Revision History

400 W Cesar Chavez Austin, TX 78701	
SILICON LABS			
Title Mini Simplicity Adapter			
Size B	Document Number IST-A0088		Rev 2.0
Date:	Tuesday, July 26, 2016	Sheet 1 of 2

Rev 2.0

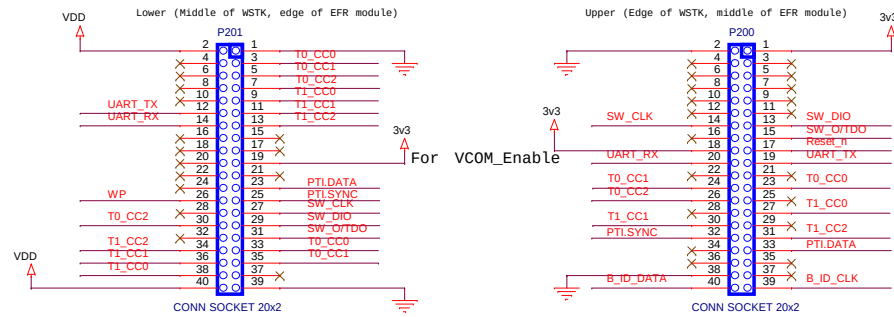
EEPROM address changed to 001.

Added in TP to allow changing address to 000 temporarily.
